HEADWATERS SUBDIVISION,

APPLICATION NUMBER 16 DATE May 1, 2008

REQUEST Subdivision

DETAIL SITE PLAN

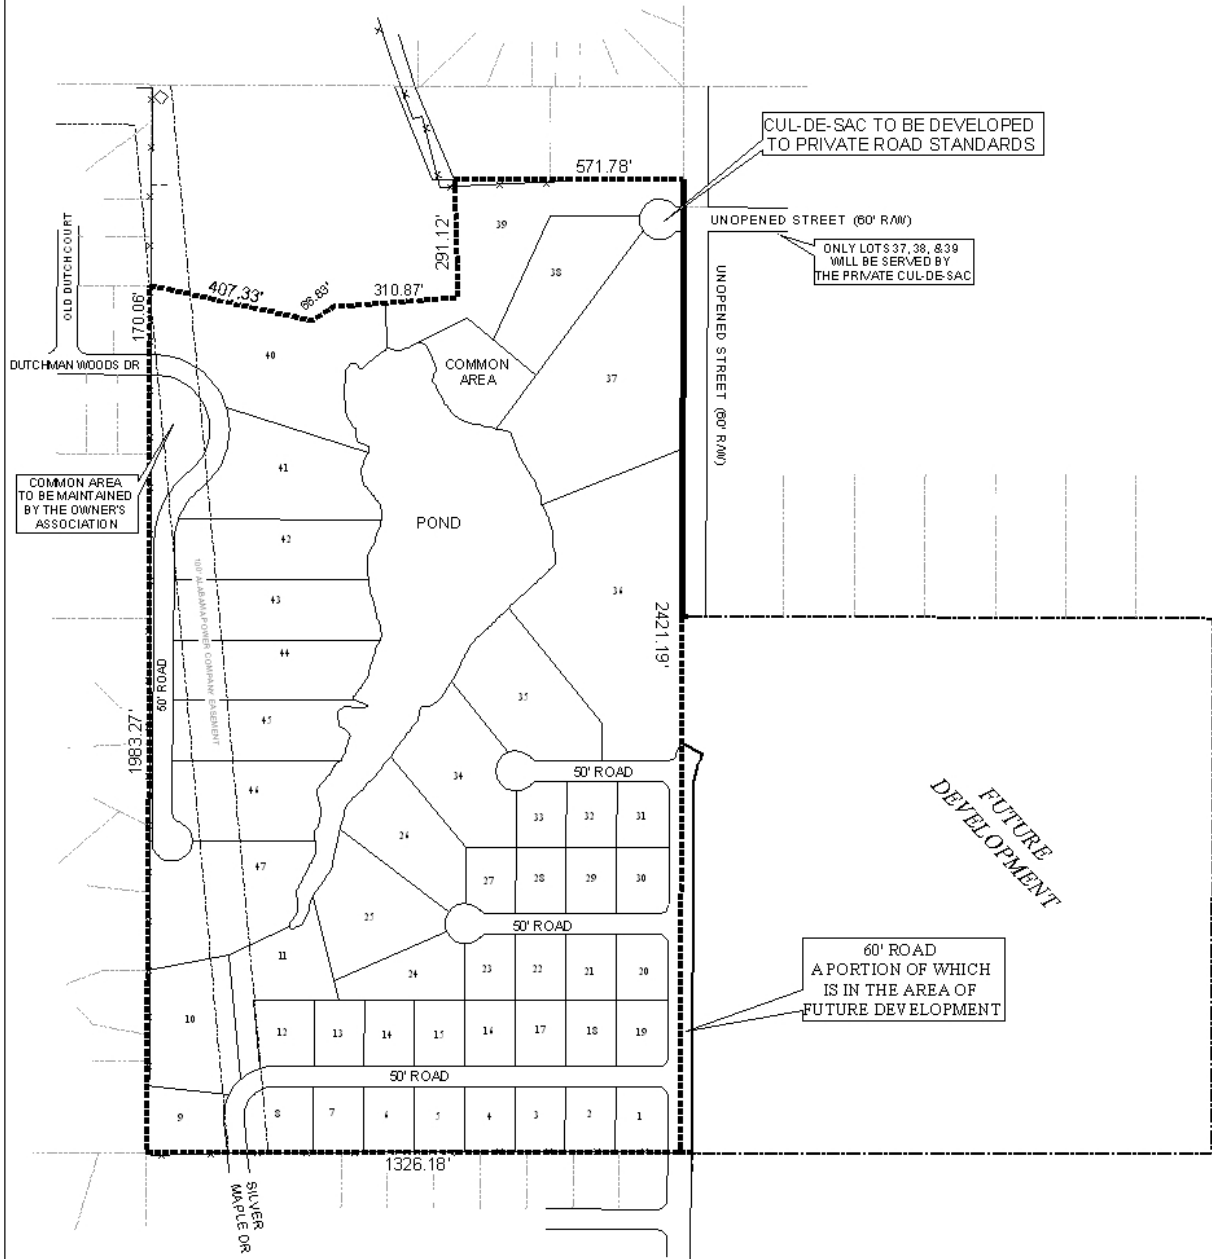
As illustrated on the preliminary plat, a portion of the 60-foot right-of-way accessing a major portion of the development is located within the "Future Development Area". Therefore, the entire 60-feet dedicated right-of-way should be included within the 48-lot development. It should also be mentioned that further development of the "Future Development Area" will require the extension of the 60-feet of right-of-way to connect with the unopened 60-feet right-of-way.

Access management is also a concern. As Lots 1, 8, 19, 20, 30, 31, 36, & 37 are corner lots therefore, a note should be placed on the Final Plat limiting each lot to one curb cut each, with the size, design and location to be approved by County Engineering and conform to AASHTO standards.

As illustrated on the preliminary plat, the site contains a private lake, which indicates that the area may be environmentally sensitive; therefore, the approval of all applicable federal, state and local agencies would be required prior to the issuance of any permits or land disturbance activities.

Detention/retention or common areas are depicted on the preliminary plat; therefore, a note should be placed on the Final Plat stating maintenance of these areas will be the responsibility of the property owners.

The 25-foot minimum building setback is not shown on the plat, but is required. The setback line should be depicted on all street frontages and labeled.

- 1) all roads within the subdivision (including the cul de sac at the terminus of Nugget Drive) be constructed and dedicated to County standards;
- 2) the approval of all applicable federal, state and local agencies for wetlands prior to the issuance of any permits or land disturbance activities;

- 5) the placement of a note on the Final Plat limiting Lots 1, 8, 19, 20, 30, 31, 36, & 37 to one curb cut each, with the size, design and location to be approved by County Engineering and conform to AASHTO standards;

- 6) revision of the plat to label the lots with the size in square feet, or placement of a table on the plat with the same information;
- 7) depiction of the 25-foot minimum building setback lines from all street frontages;
- 8) the placement of a note on the final plat stating that any lots which are developed commercially and adjoin residentially developed property must provide a buffer, in compliance with Section V.A.7 of the Subdivision Regulations; and
- 9) placement of a note on the plat stating that maintenance of the detention and common areas is the responsibility of the subdivision's property owners.
